Reference: 20220270-L02_flood study report [C].docx

RE: PLANNING PROPOSAL AT 34 QUEEN STREET, CAMPBELLTOWN – FLOOD IMPACT & RISK ASSESSMENT

This report is amended to address the request for information letter received from the Department of Planning and Environment (DP&E) included in Appendix 4.

Figure 4 Flood Evacuation Route for Storms up to 5% AEP

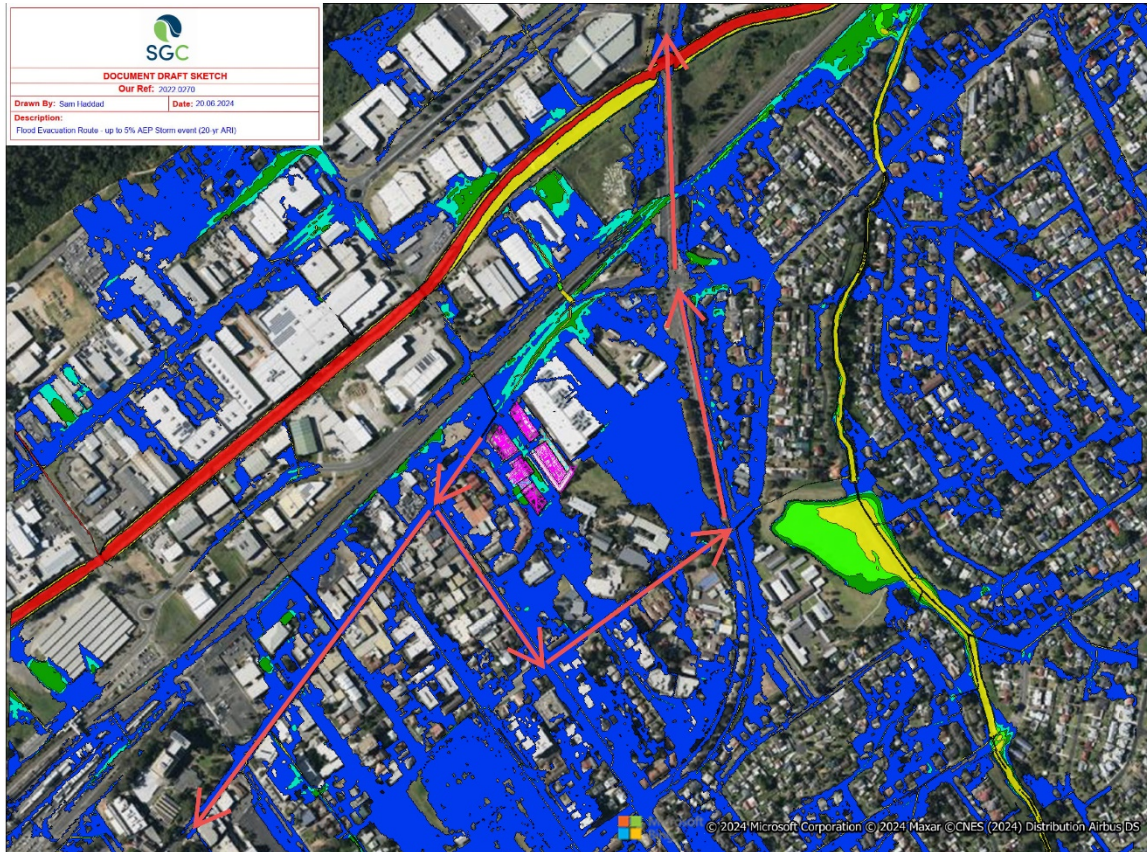
According to the Bow Bowing Bunbury Curran Creek Strategic Floodplain Risk Management Study and Plan, the site access may be affected at least as frequently as in the 20% AEP event. It appears no attempt has been made to ascertain if the site would be isolated more frequently than that. With frequent isolation, EHG raises serious concerns for access and egress to the site.

Queen Street is flooded relatively frequently, which may mean there is no suitable site access. Day to day access should be considered separately to evacuation. Even if a shelter in place strategy were adopted, the frequency of loss of access remains a major concern. Access may be lost in events as small as the 20% AEP flood event, and possibly even more frequently, but EHG does not have access to data on more frequent events.

As previously mentioned in the "Discussion" section above, access and egress to and from the site is available via the south side of Queen Street which is not a high hazard for all frequent storms and

also for less frequent storms up to the 5% AEP (20-YR ARI). With the vehicular site entry being proposed along the southern boundary, this also makes it more appropriate for emergency vehicles to reach the southern end of the site.

Below is a diagram of a possible evacuation route from the site for frequent storms and other larger storms up to the 5% AEP.
